Inspection of Automatic Sprinkler System

FE1 Hop Refab East London Industrial
Development Zone

UNC.8803

Photo 14

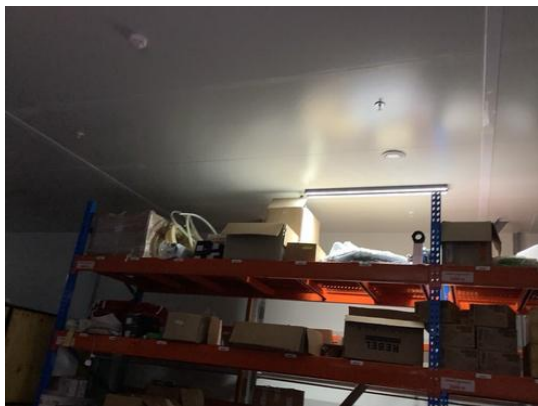
The system pressure has exceeded the maximum allowable pressure of 1200 kPa, this must be investigated and rectified by your installer.

Photo 23

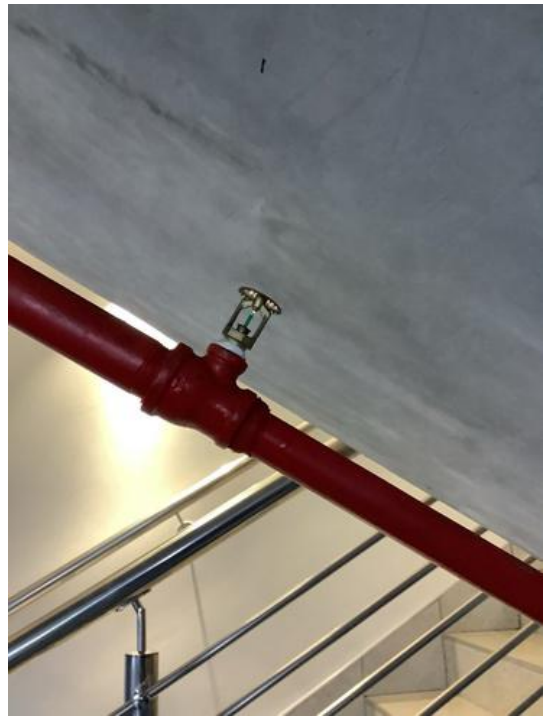
Shelves exceed 1,0 metre in width.

The shelves must be reduced to a maximum width of 1,0 metre or intermediate sprinkler protection will be mandatory at each shelf tier level.

Photo 31

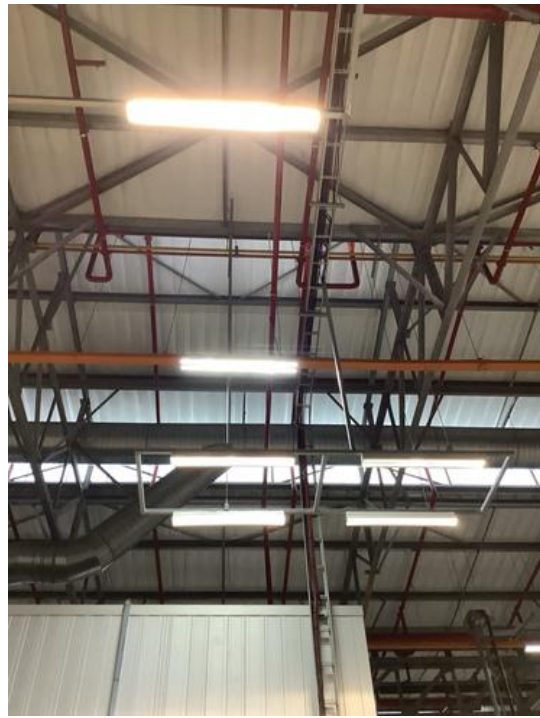
The sprinkler pipe work must be correctly supported.

Pipe work must be supported independently from the composite panel

Photo 37

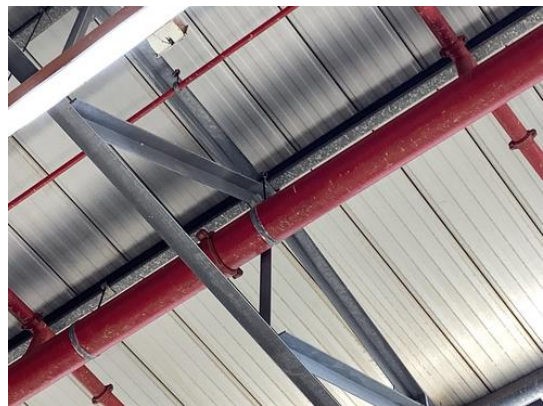
The sprinkler pipe work must be correctly supported.
